Subject : Current Configurations of Pressure Suit and Parachute

The results of the meeting on January 16 thru 18 with regard to changes in the pressure suit and parachute are as follows:

FULL PRESSURE SUIT 1962
OXCART

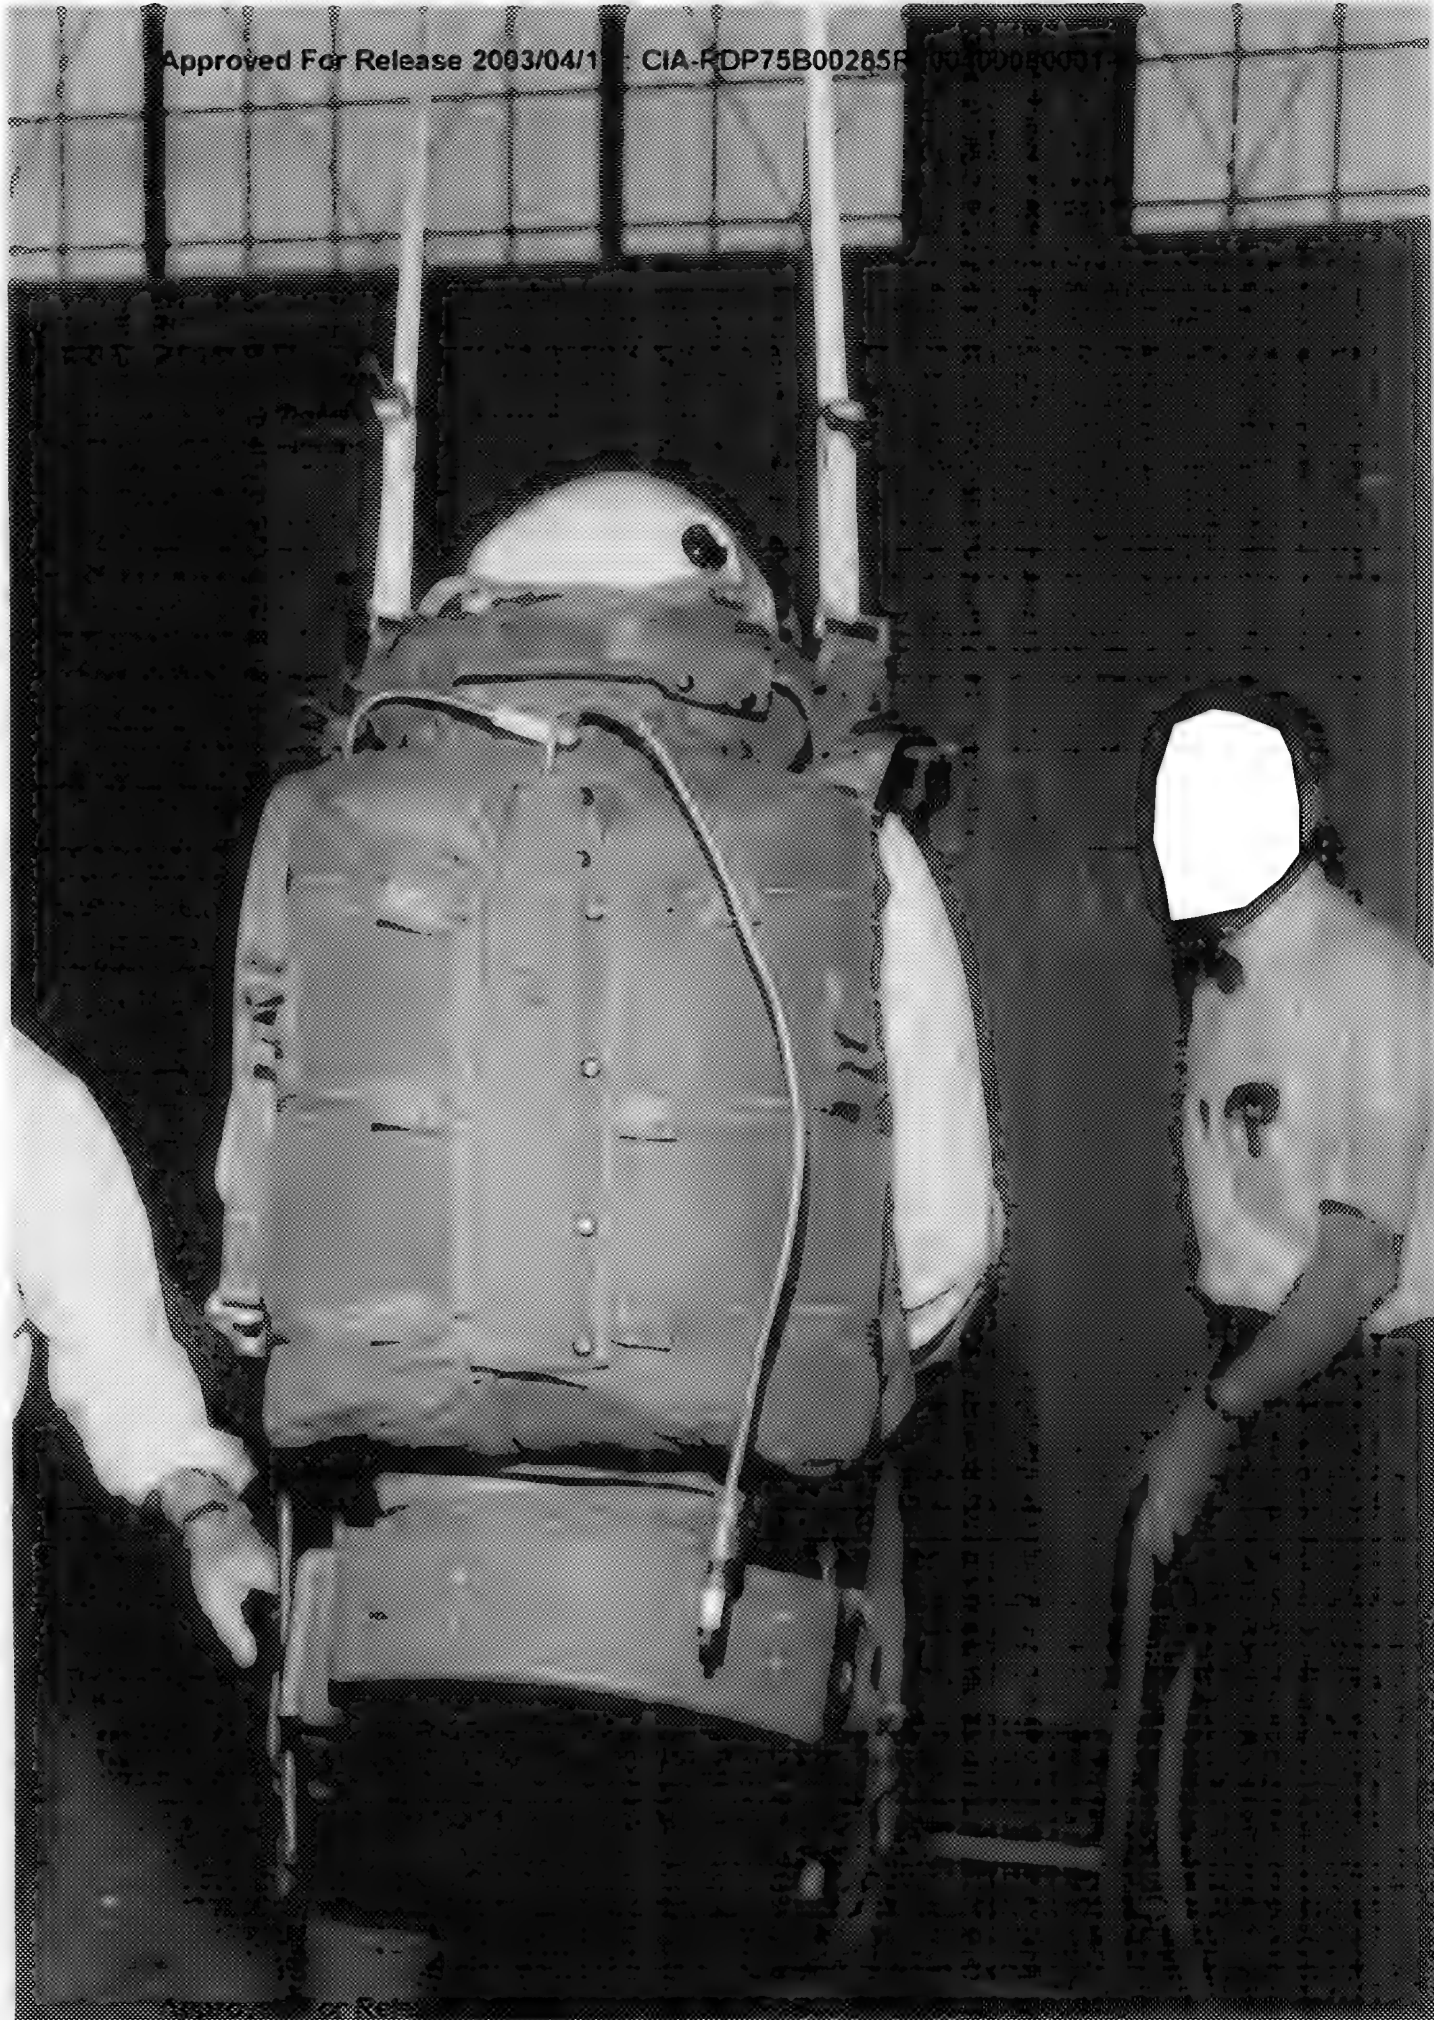
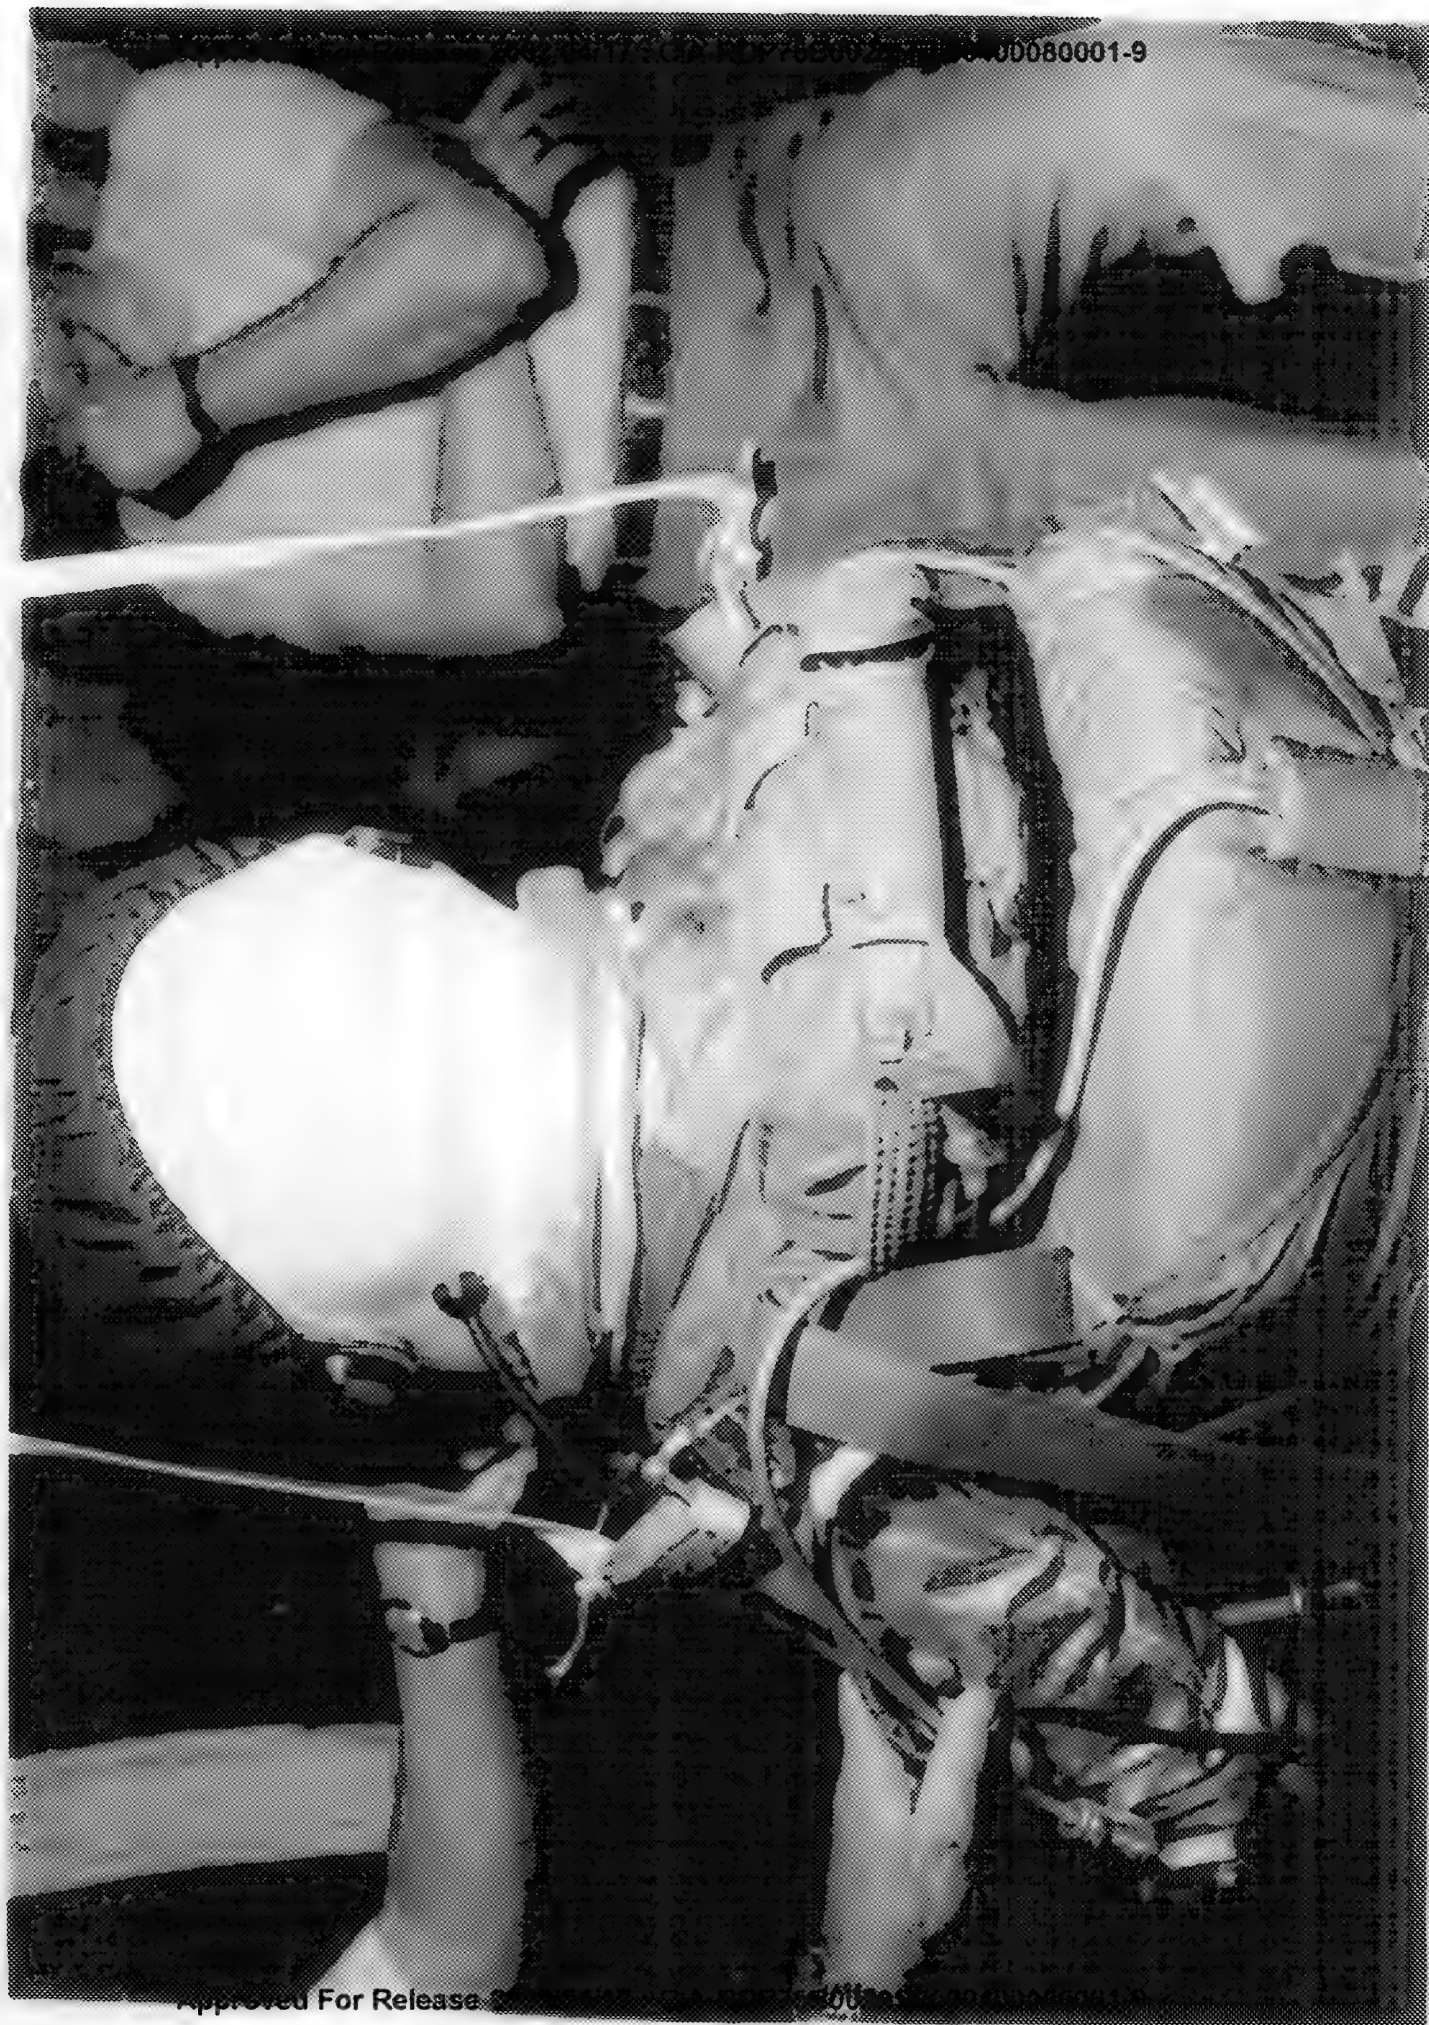
a) SUIT AND NECK-SPREADER COLLAR

A) SUSPENSION AFT POSITION

a) CONSIDERS SUSPENSION ACCEPTABLE

b) LEG AND GROIN OK

c) NO NECK PRESSURES

d) CHEST PRESSURES APPEAR OBVIOUS
FROM MANNER OF SUSPENSION

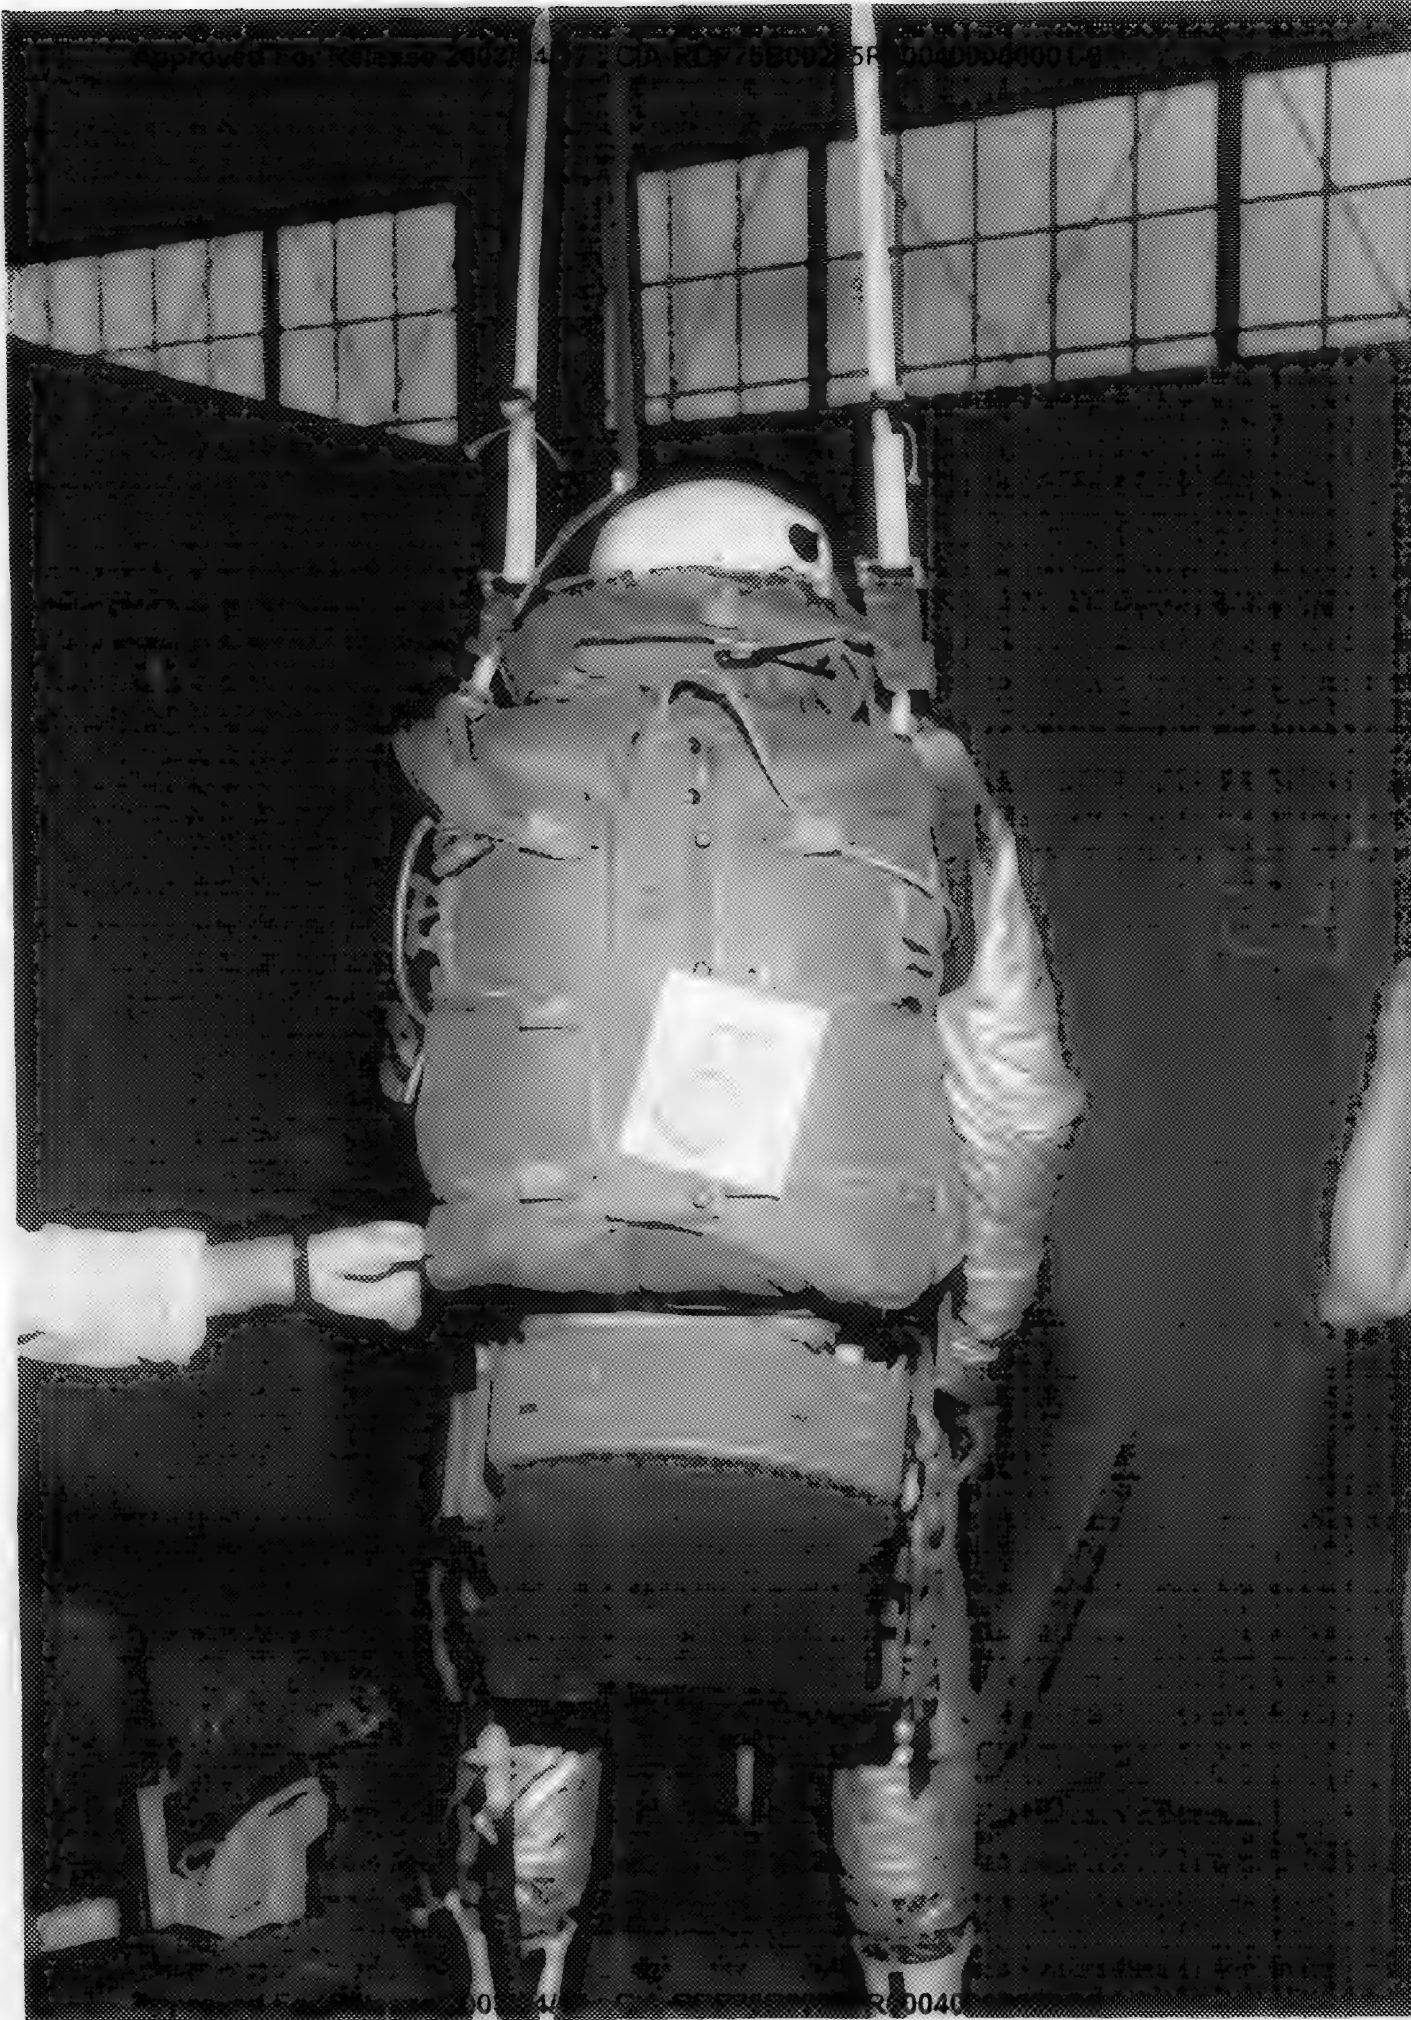
- a) SAME AS #4 WITH 5" F.W'D
POINT 1" F.W'D
- b) ~~HIS~~ NECK COLLAR PLACED OUTSIDE

- a) FEELS MORE COMFORTABLE THAN #4
- b) CHEST PRESSURES LIGHTER THAN #4
- c) NO NECK PRESSURES
